WCAP-7219

ADDENDUM TO SAXTON CORE III
LICENSE APPLICATION

ADDENDUM TO SAXTON CORE III LICENSE APPLICATION

Figure 1: Schematic diagram of load follow assembly cross section showing general arrangement. (All positions not otherwise noted are occupied by fuel rods.)

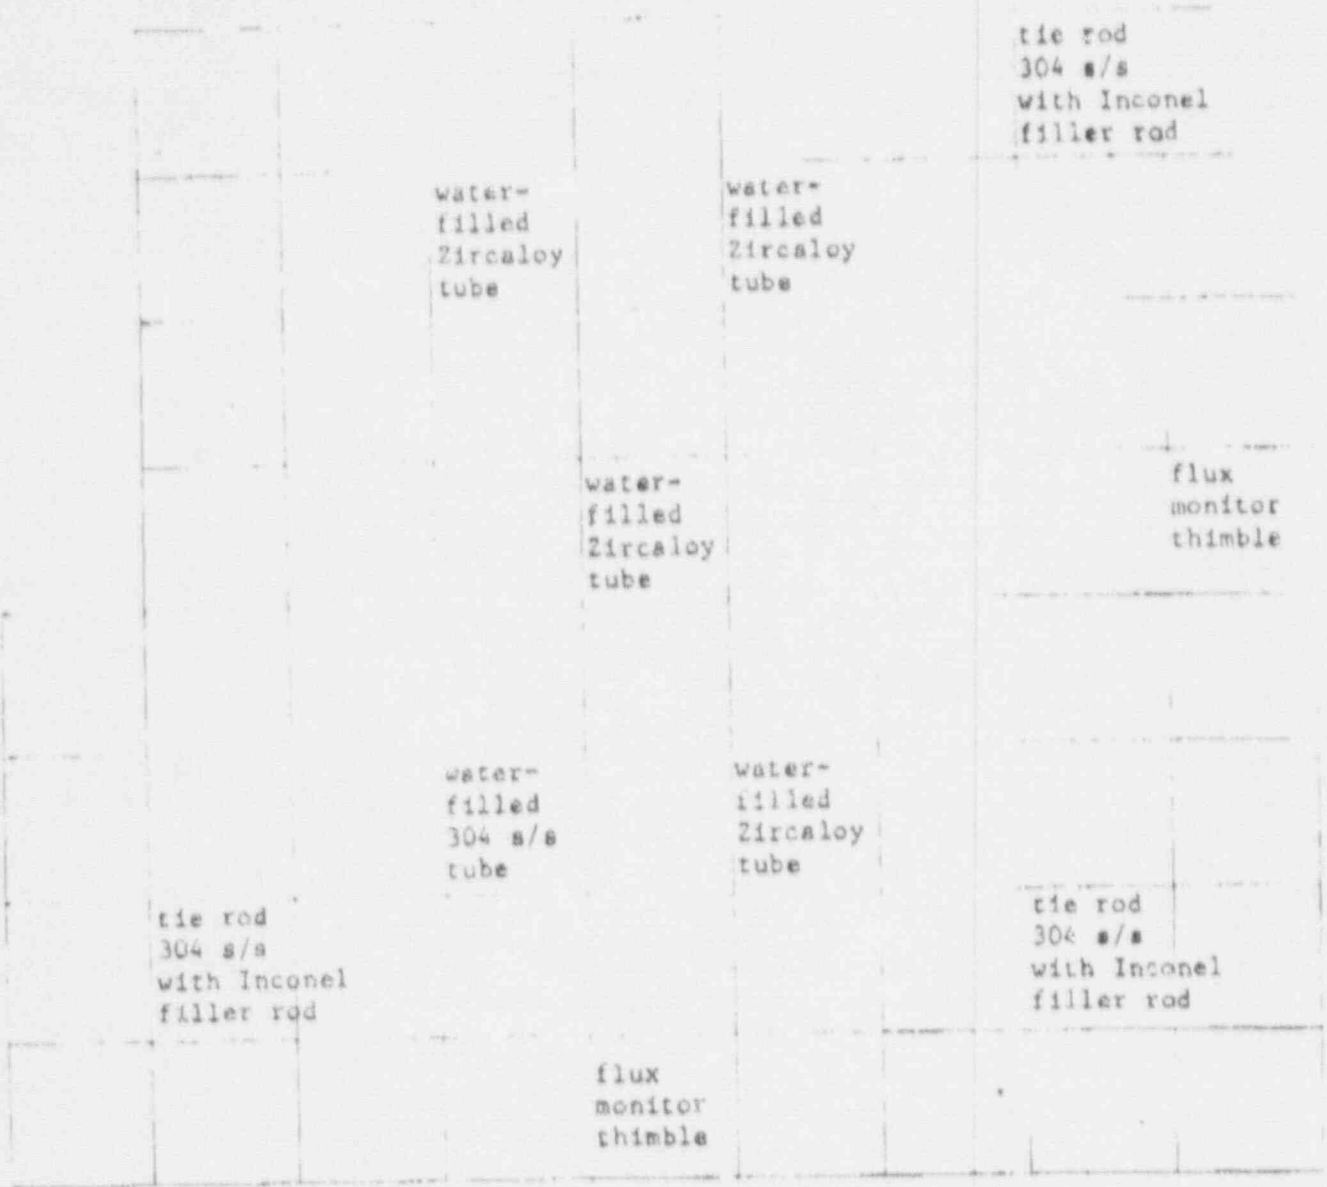
The load follow assemblies are similar in design to previous Saxton assemblies. The arrangement of fuel rods and other fuel bundle components of the assemblies is shown in cross section in Figure 1. Three tie rods hold the removable top nozzle in place. Two tie rods are Inconel-filled stainless steel tubes and the third tie rod is a stainless steel tube with a stainless steel filler rod. Five water-filled tubes are used to increase the water-fuel ratio in the center of the assembly and thus increase the power level of the adjacent fuel rods.
